STAFF RECOMMENDATION 1404 Benjamin Street December 21, 2016

Application: New construction—detached accessory dwelling unit
District: Eastwood Neighborhood Conservation Zoning Overlay
Council District: 06
Map and Parcel Number: 08301043000
Applicant: Ben Azzi
Project Lead: Melissa Sajid, melissa.sajid@nashville.gov

Description of Project: Application is to construct a detached accessory dwelling unit (DADU) with a footprint of four hundred and seventy-eight square feet (478 sq. ft.) at the rear of the lot.

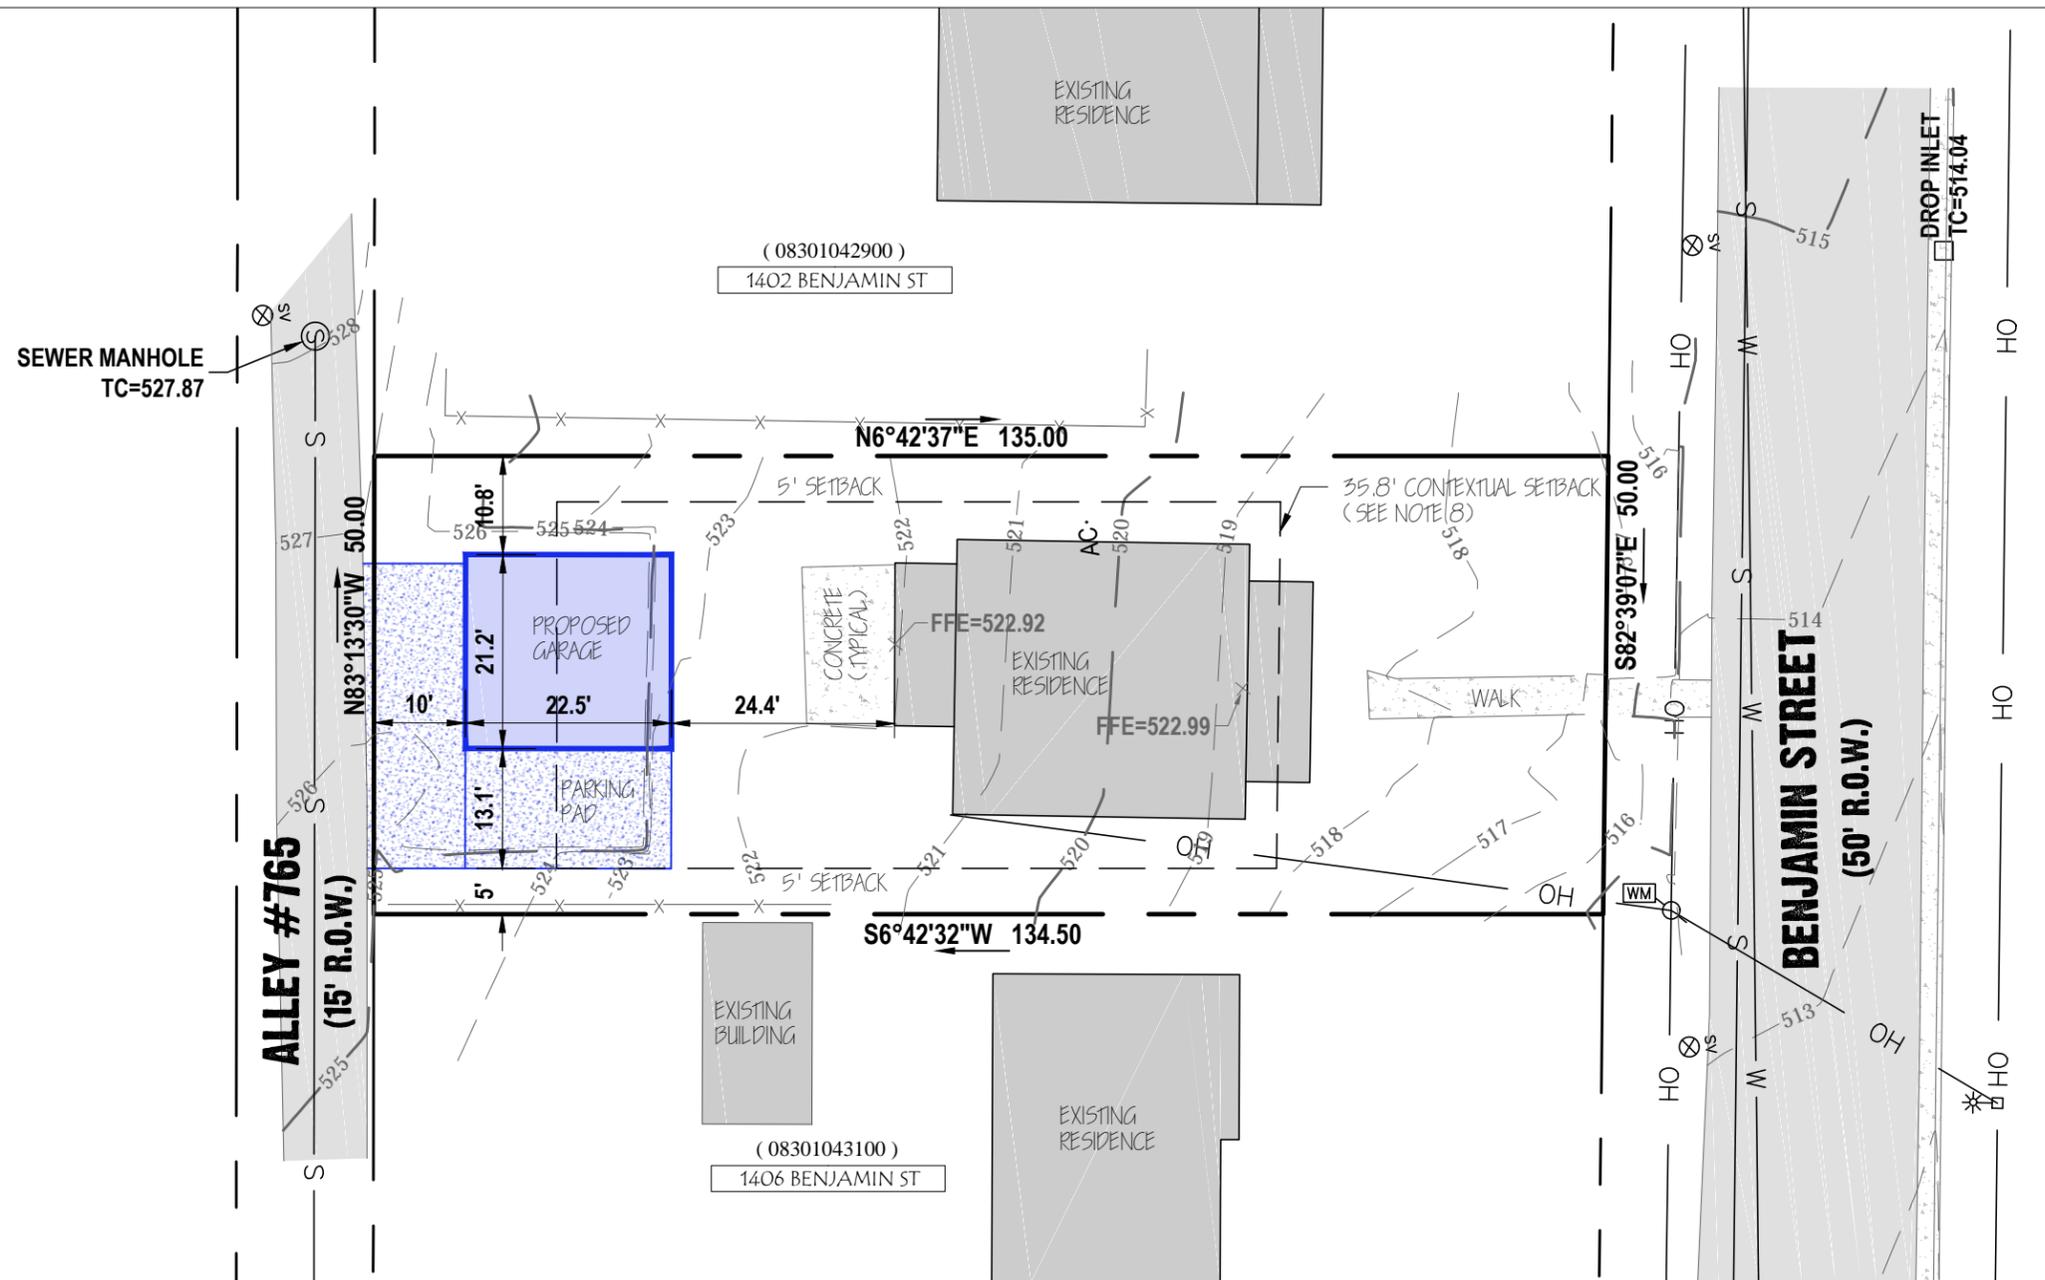
Existing conditions (height of historic portion of the home to be measured from finished floor)	Potential maximums (heights to be measured from grade)	Proposed (should be the same or less than the lesser number to the left)

Ridge Height	23'-6"	25'	21'-10"
Eave Height	10'-10"	10'	9'-8 1/2"

Lot is less than 10,000 square feet	50% of first floor area of principle structure	Proposed footprint
Maximum Square Footage	750 sq. ft.	480 sq. ft.	478 sq. ft.

Staff finds that the proposed DADU meets Section II.B.1.h. of the design guidelines and 17.16.30.G. 7 of the ordinance.

A-1

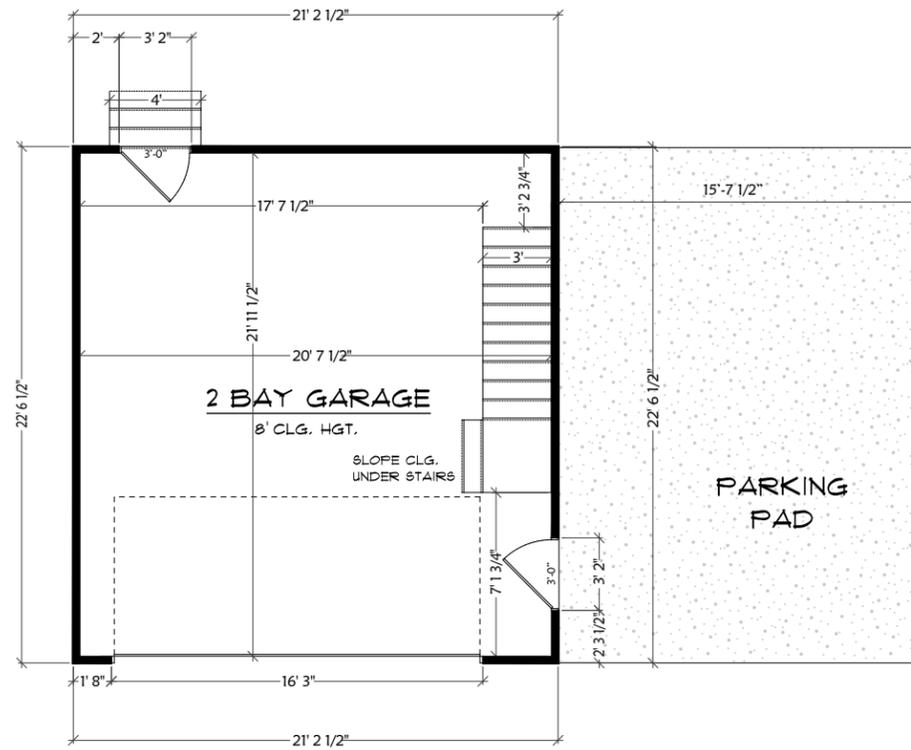
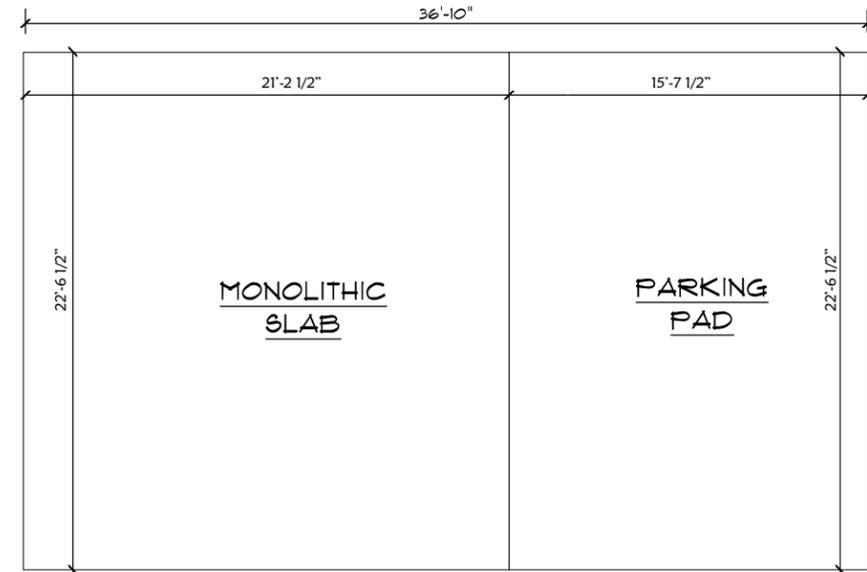
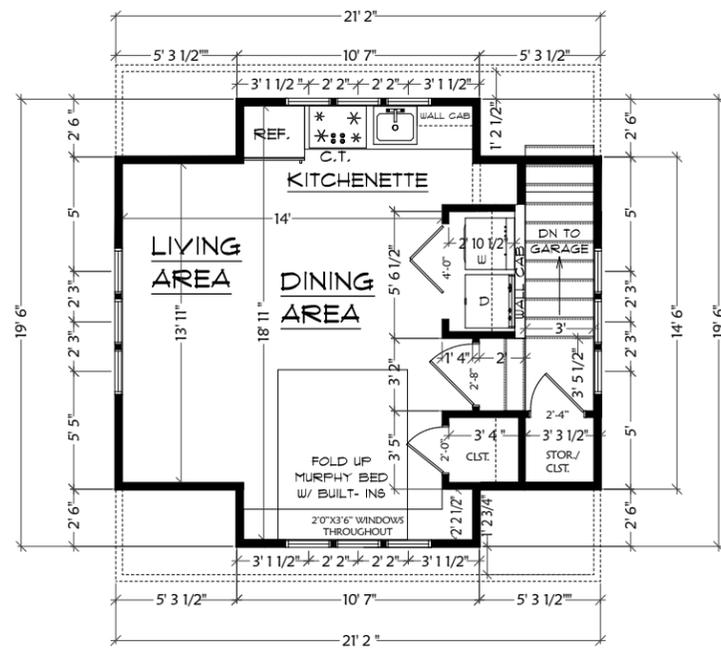
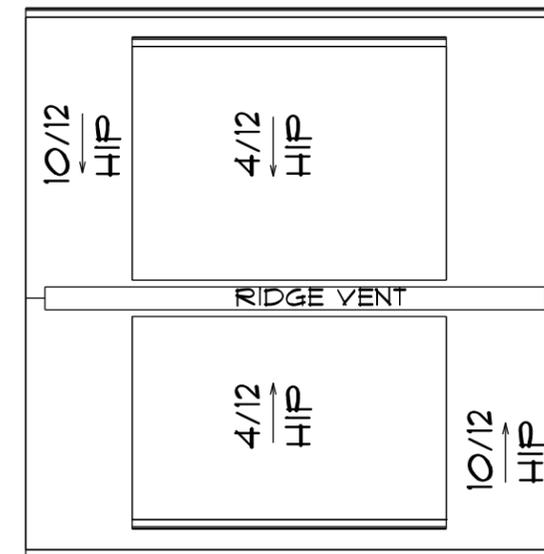
MINIMUM	PROPOSED
Space between principal building and DADU/Garage	20'	24.4'
Rear setback	10'	10'
L side setback**	3'	13.1'
R side setback**	3'	10.8'
How is the building accessed?	From the alley or existing curb cut	Alley

The proposed DADU meets all setbacks required by zoning and maintains a separation of at least twenty feet (20') between the house and the DADU. Staff finds that the project meets Section II.B.1.h. of the design guidelines and 17.16.030.G. 4 of the ordinance.

A-2

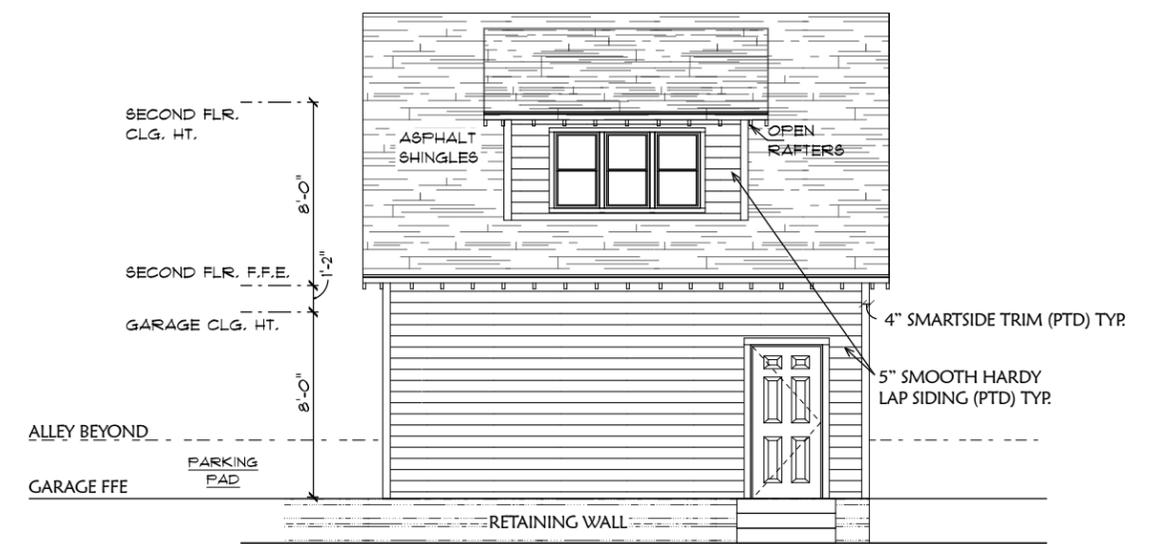
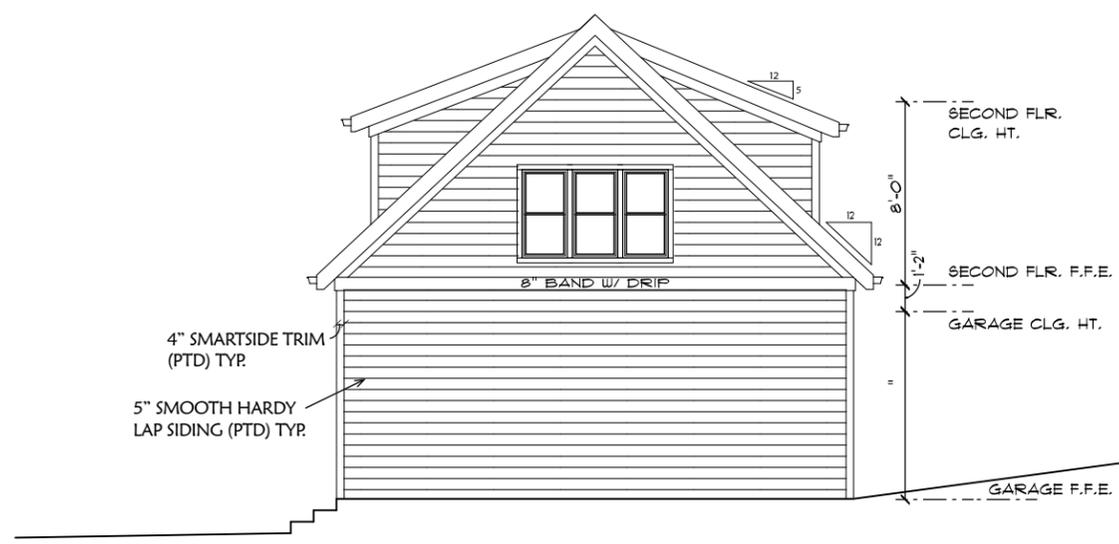
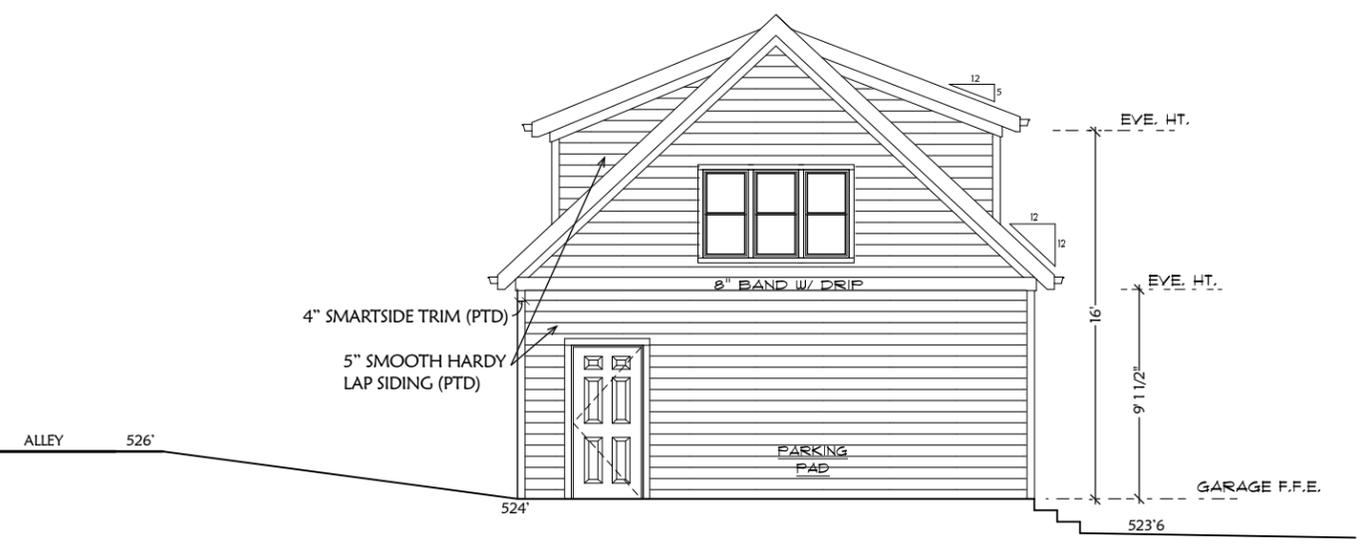
Proposed Element	Proposed Form	Typical of district?
Primary form	Gable	Yes
Primary roof slope	10/12	Yes
Dormer form	Shed	Yes
Dormer slope	4/12	Yes

Since the form and slopes are similar to historic outbuildings, the project meets Section II.B.1.h. of the design guidelines and section 17.16.030.G.8 of the ordinance.

Design Standards: The accessory structure has a simple, utilitarian design that is appropriate for outbuildings. Its roof form, detailing, and form do not contrast greatly with the primary structure. It is similar to other DADUs that have been approved by the Commission in the past. The design meets section II.B.1.h. of the design guidelines and Section 17.16.030.G.8 of the ordinance.

The plan proposes LP Smartside for the trim. The Commission has not approved this material before as it is difficult to achieve a smooth finish as required by the design guidelines. Staff recommends that the applicant use another product such as Miratec, Hardie trim, or wood that can meet the design guidelines. With the staff’s final approval of the trim, foundation, windows, doors, driveway, and retaining wall materials, staff finds that the known materials meet Section II.B.1.h. of the design guidelines.

1. Staff receive a copy of the filed restrictive covenant for the detached accessory dwelling unit prior to issuance of a permit;
2. Staff approved the materials for the trim, foundation, windows, doors, driveway, and retaining wall prior to purchase and installation; and
3. The HVAC be located either at the sides or rear of the structure.
